AIRPORT LAND USE COMMISSION RIVERSIDE COUNTY AGENDA

09-AFC-6

Thursday 9:00 a.m., June 10, 2010

- 2.1 ZAP1015FL10 – Riverside County Economic Development Agency, for Riverside County Regional Park and Open-Space District – (Representative: Jill Efron/RHA Landscape Architects Planners Inc.) - Rancho Jurupa Sports Complex (Amended proposal) – A park with soccer fields, including lighted soccer fields, picnic shelters, playground with play structures, restroom/concession building, and storage building, on a 36.54-acre site located northerly of Crestmore Road and 46th Street, westerly of Loring Ranch Road, and southerly of Flabob Airport in the unincorporated Riverside County community of Rubidoux. ALUC Staff Planner: Russell Brady at (951) 955-0549, or e-mail at rbrady@rctlma.org. or John Guerin at (951) 955-0982, or e-mail at jguerin@rctlma.org.

Figure 5. Revised Gen-Tie Line Route, 05/04/10

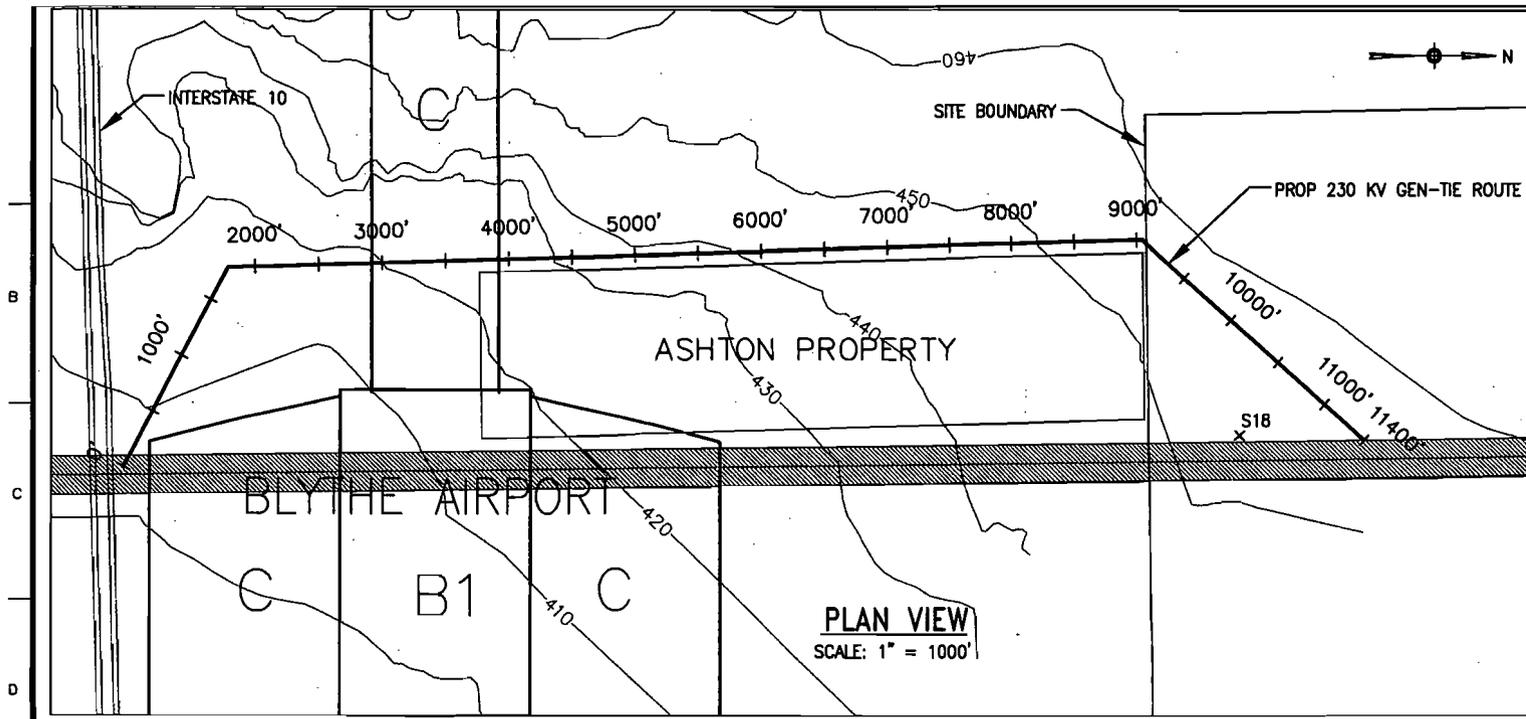
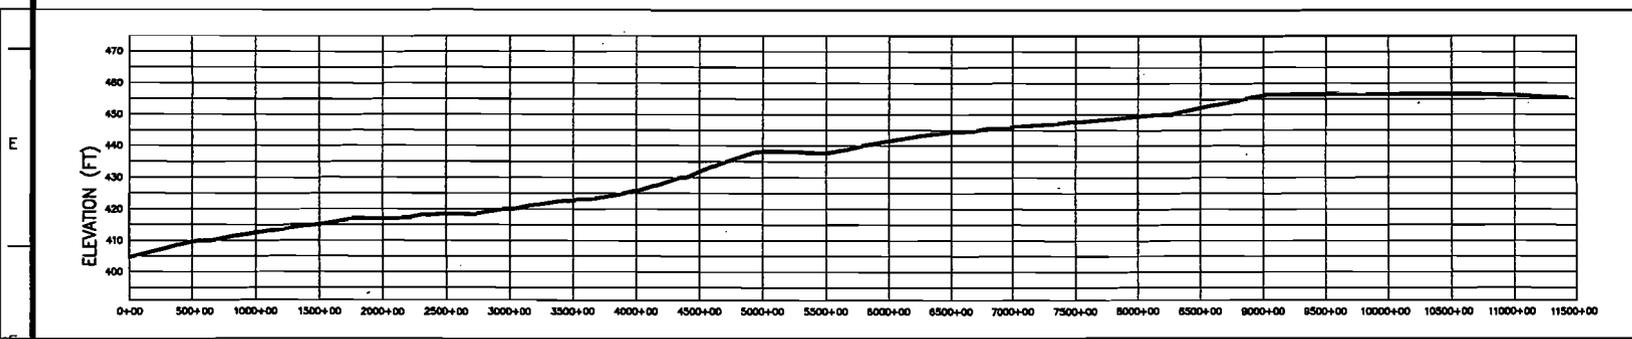
As noted above, the Applicant is proposing to reroute the transmission line to avoid crossing Compatibility Zone B1. Figure 5 presents the elevation profile for the newly proposed Gen-Tie route that avoids Compatibility Zone B1. Note that the figure is oriented with west to the top of the figure.

Figure 7 Elevation Profiles West of Extended Runway 26 Centerline

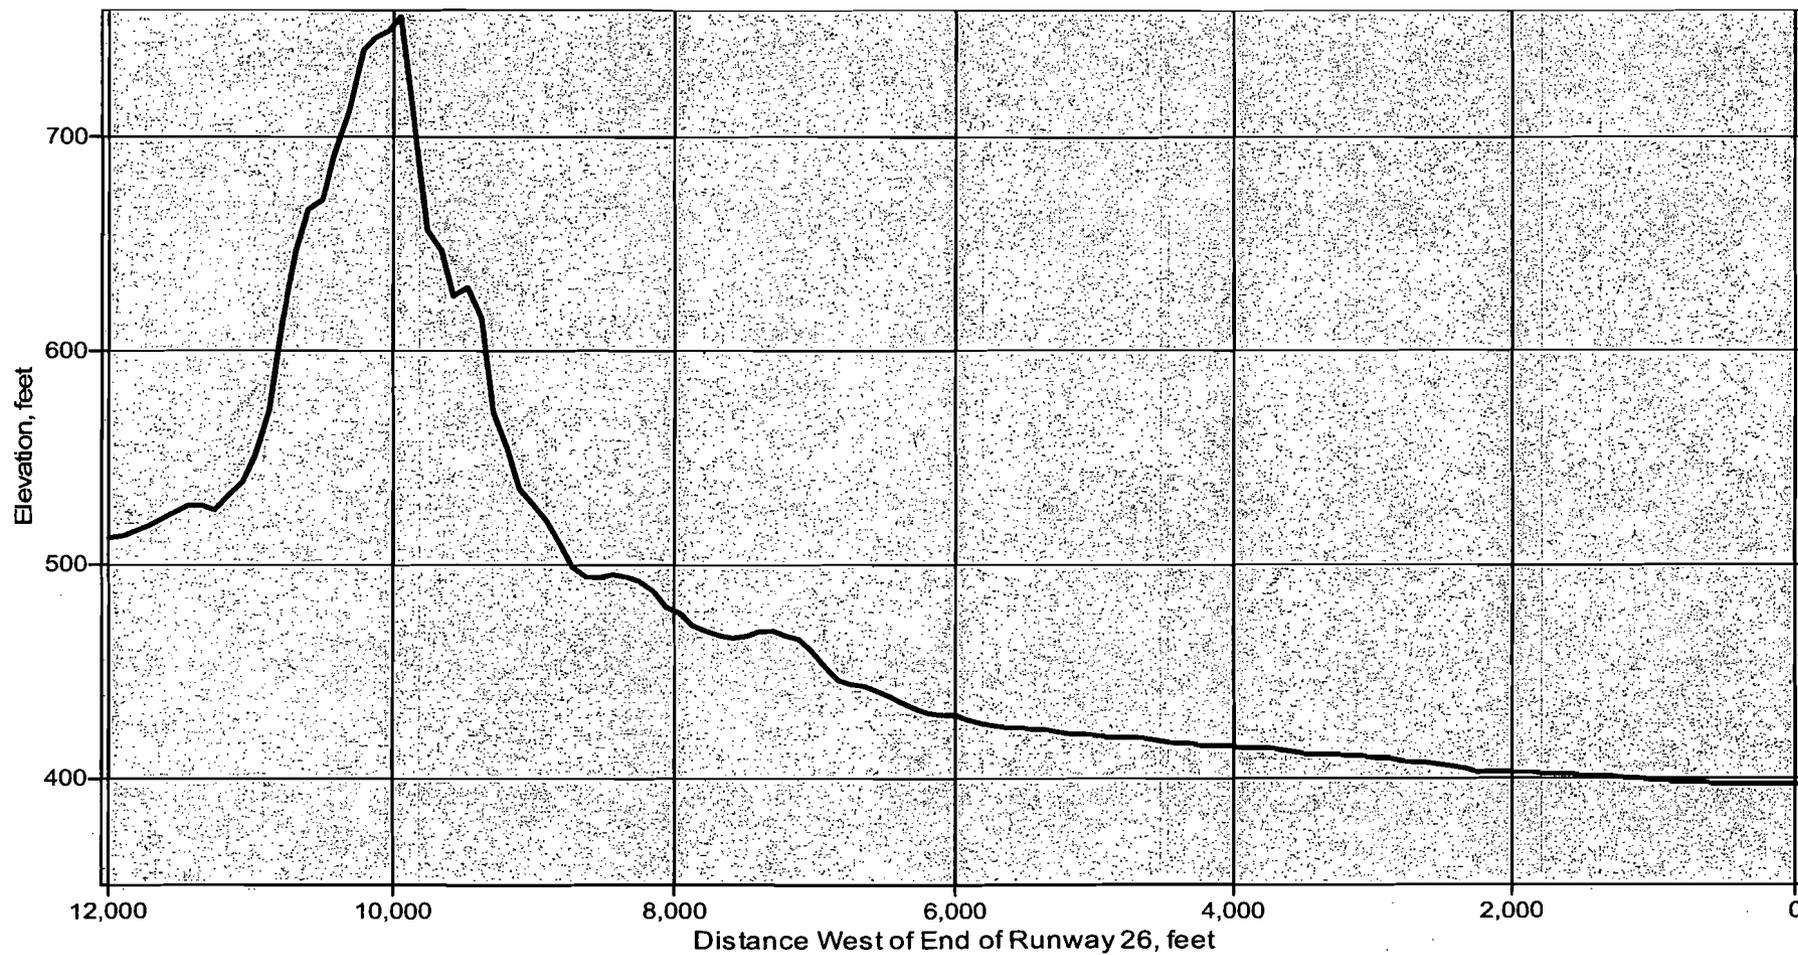
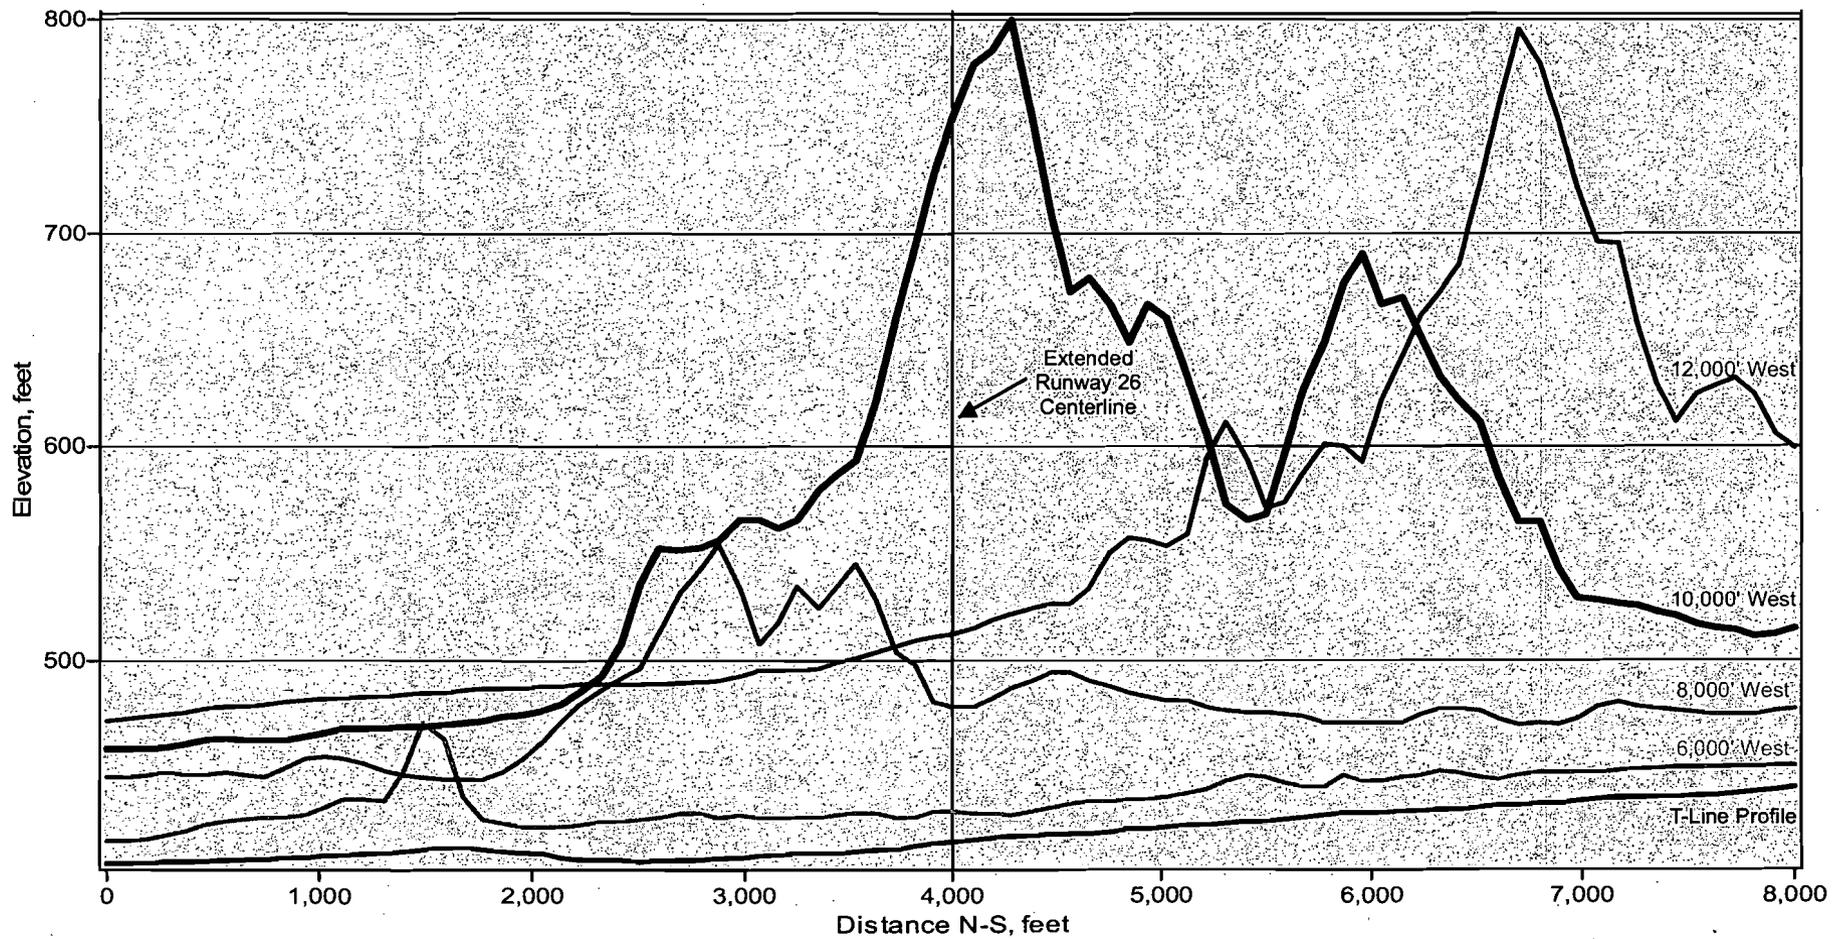
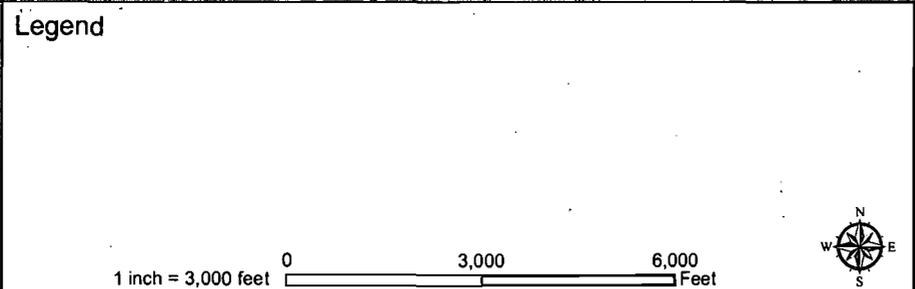
Figure 7 presents a series of north-south elevation profiles spaced approximately 2,000 feet apart west of the end of Runway 26. Each successive profile west is higher than the proceeding profile. Only at the 12,000 profile does the terrain fall on the far side of the McCoy Mountains. Figure 8 presents a map showing the locations of the east-west profile and the north-south profiles. The Transmission line would have to be located to the west of the McCoy Mountains for it to not pass over zone C. However, the routing for such a transmission corridor would be problematic since it would have to cross over the McCoy Mountains to allow the poles to the west of the runway to be on the far side of the mountain.

Figure 11. Power Block 4, Airport Compatibility Zone, and Wind Rose for Blythe Airport

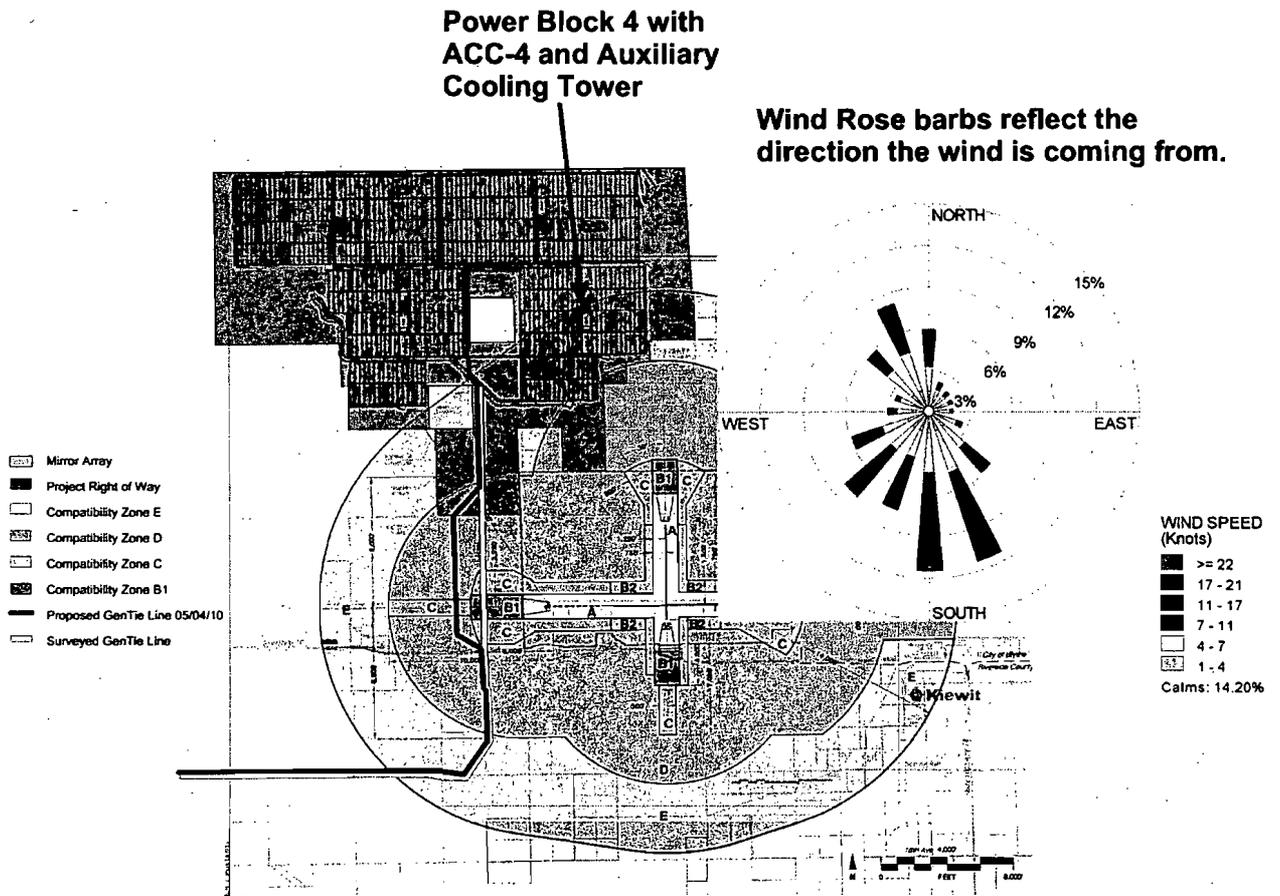
There is a potential for the plume from the ACC-4 to drift into the Airport Compatibility Zone. Figure 11 presents the location of the Project, the compatibility zone, and a wind rose. A wind rose is a meteorological diagram that graphically displays the frequency of occurrence of the distribution of wind speed and wind direction at a measurement location. In the wind rose, the individual barbs represent the wind blowing from a given direction, with the length proportional to the frequency of wind flow from that direction. For example, in Figure 11, the wind barb at the top of the figure represents the frequency of time the wind blows from the north to the south. Since the length of the wind barb extends to the 6% circle, the frequency of winds blowing from the north at the Blythe Airport is 6%. Encoded on the wind barb by color are the relative frequencies of winds of various speeds for that given direction.

Approximately 20% of the time, the wind as measured at the Blythe airport (2002-2004) could cause any plume from ACC-4 to advect to the south and southeast over the AIA. For the remaining approximately 80% of the time, the ACC plume will either rise vertically due to calm winds or will advect in a general northward direction away from the AIA. Please note that the blue, red, and green colors on the wind rose in Figure 11 represent occurrences of wind speeds 7 knots and greater. At these speeds, wind shear across any ACC plume will tend to rapidly dissipate the plume and will reduce or eliminate any potential for turbulence in the plume to affect aircraft operations. Consequently, the frequency of occurrence of ACC plumes that could advect into the AIA and potentially pose a hazard to aviation is well less than 20%. The most problematic time for potential turbulence from the ACCS will be during periods of calm winds, which generally occur at night and in the early morning hours.
